**Tuesday, November 8, 2022
Virtual Platform
57 East 1st Street
4:30 PM**

- 3a DRB22-00784 - District 6.** Within the 9200 to 9300 blocks of East Cadence Parkway (north side). Located south of Ray Road and east of Ellsworth Road. (4± acres). Design review for a commercial development. Ellie Brundige, Gammage & Burnham, Applicant; PPGN-ELLSWORTH, Owner.

3b DRB22-00920 - District 6. Within the 6900 block of East Southern Avenue south side). Located east of Power Road on the south side of Southern Avenue. (1+ acres). Design Review for a restaurant with drive-thru. Greg Hitchens, Applicant; Winco Foods LLC, Owner.

Site Plan

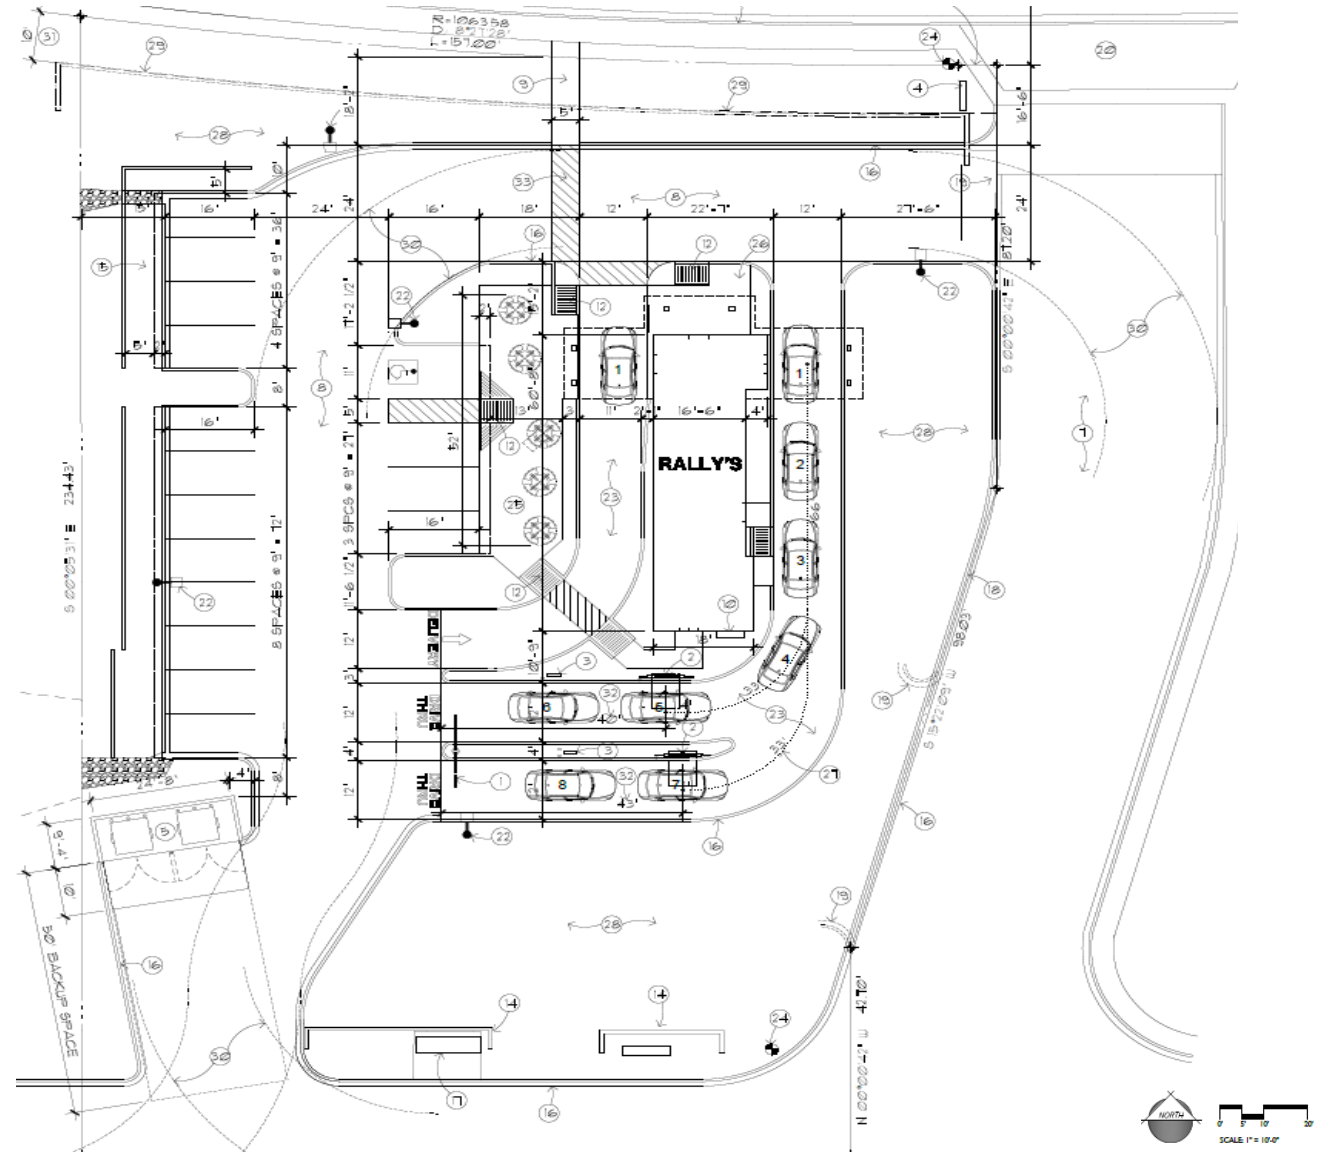
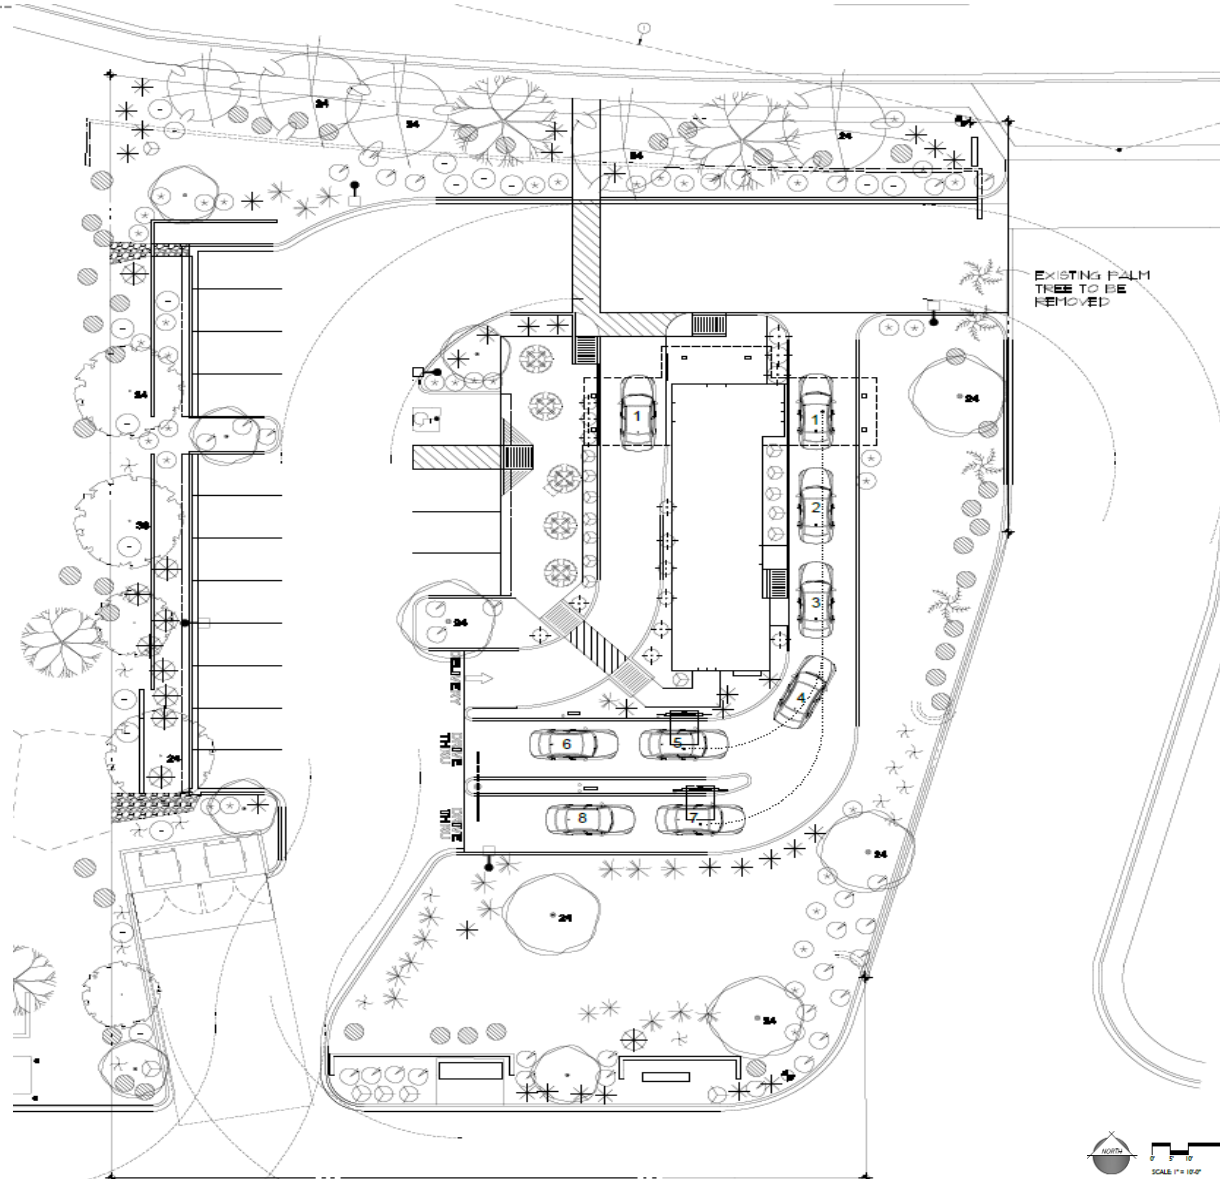
Vice Chair Green stated he had no concerns on the alternative compliance for the base treatment. He expressed concerns with pedestrian traffic crossing the delivery land and provided potential solutions.

Boardmember Astle contributed a raised walkway as a potential solution.

Staff Planner Cassidy Welch clarified that there is a requirement in the code that when pedestrian walkways cross drive aisles, they're required to be a separate material and raised three inches to give the indication to a driver that they are crossing a pedestrian walkway.

- No concerns with alternative compliance
- Change of color of the electrical panel located south of the proposed building to match the exterior color of building.
- Change of color of entrance door at the north elevation of the building to match exterior color of building.
- Distinguishing between pedestrian walkways that cross drive aisles by raising the walkway above the drive aisle.
- Relocation of trees close to trash enclosure at the southwest portion of the site.

North Elevation

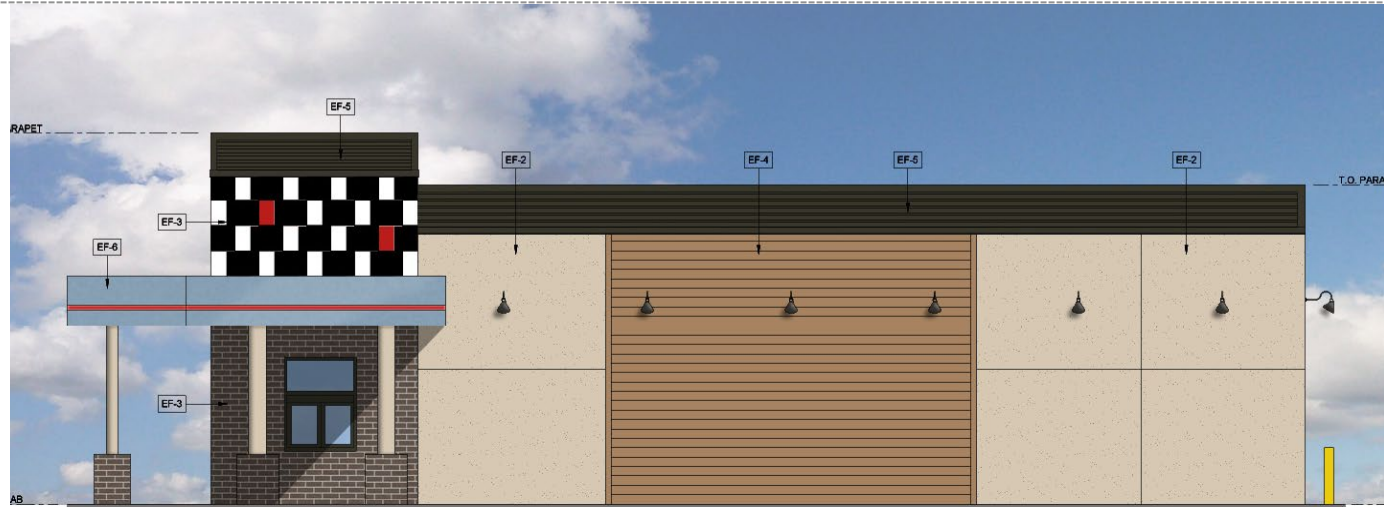
Chair Johnson stated his preference for rectangular columns. He asked for clarification on color of the door on the front elevation.

Chair Johnson added that he preferred the door color to be the same as the mullions.
